Applied Sensors v1.3 Errata – 12/8/2005

The following errors present in version 1.3 were repaired in version 1.4. The pagination for both versions is the same.

Figure 0-1: AD592 Temperature Sensor and RC-time Wiring Diagram

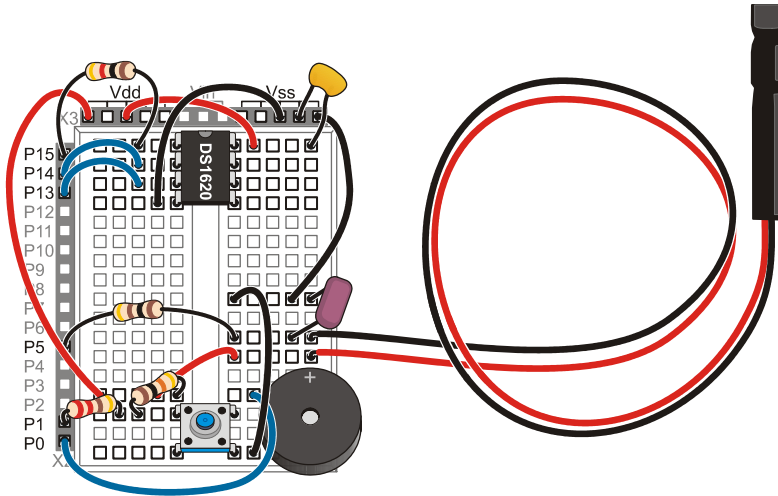
Page 67: A “phantom” wire was removed from the wiring diagram. This is the correct image for

Figure 0-2
Conductance Using the 555
Timer IC Wiring Diagram

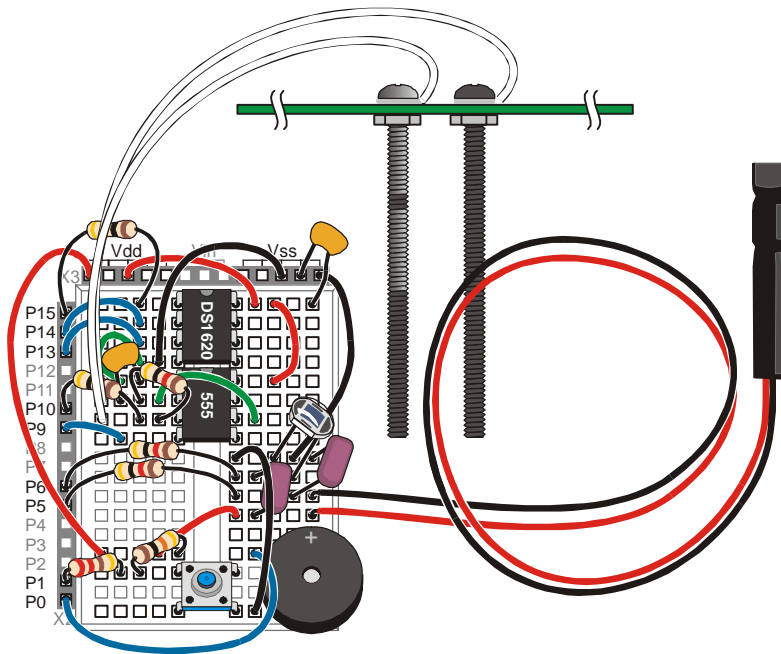
Page 129: This is the correct image for Figure 5-4:
